This page lists the know errors on the gm5x5x5 PCBs. There are no known issues with the bulk order run (white pcbs), the following information is valid **only** for the prototype run (green pcbs).

#1 MIDI IO pins

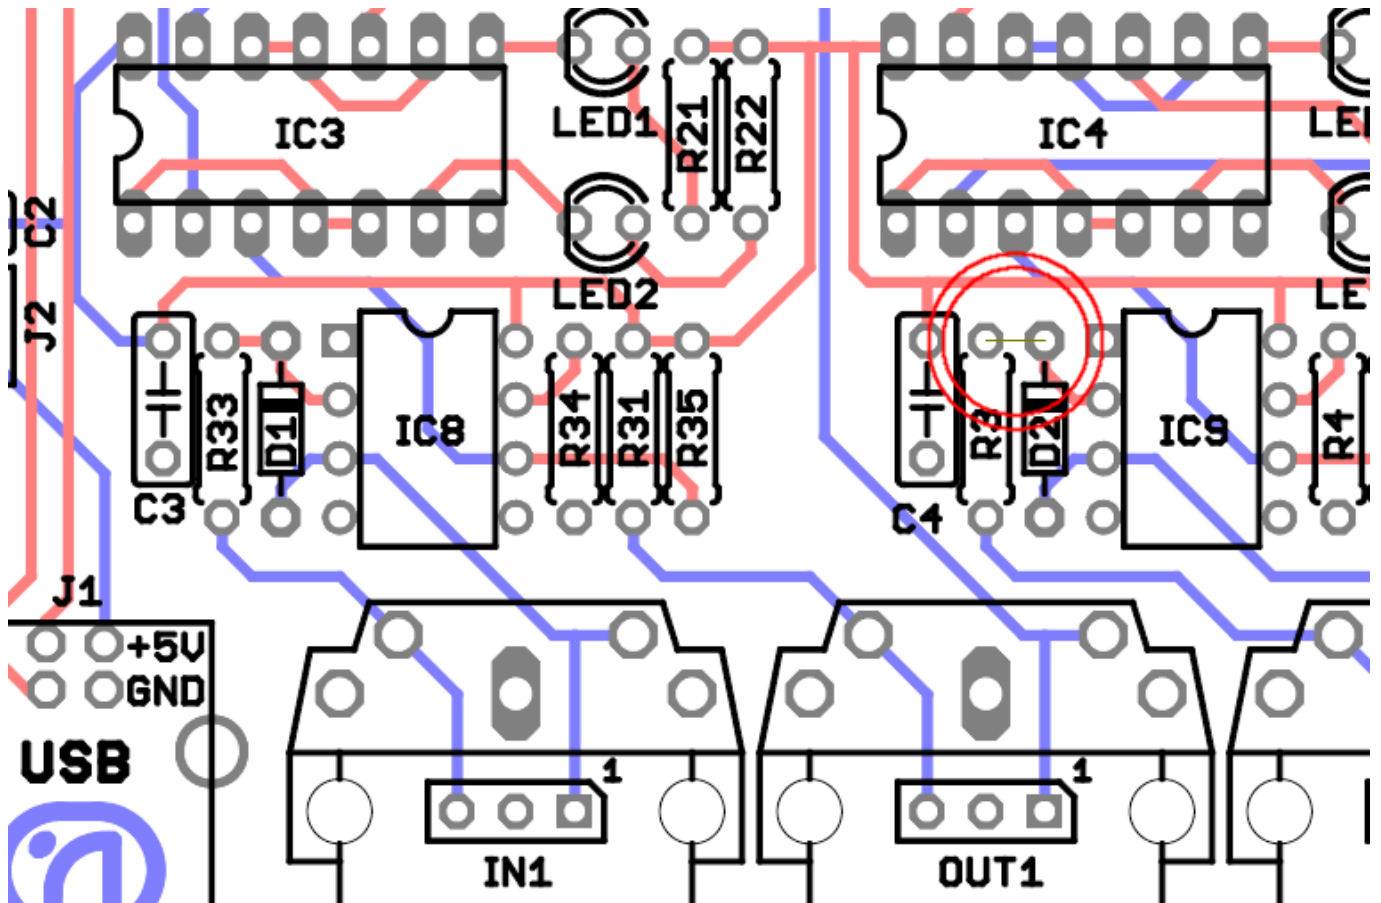
Problem: The MIDI IO pins of the midi sockets (Pin 4 + 5) are switched.

Solution: Either (1) use the pin-headers if you use sockets that are not mounted on the pcb or (2) break the traces to pins 4 + 5 of the sockets and solder wires to them or (3) solder the midi sockets on the other side of the pcb.
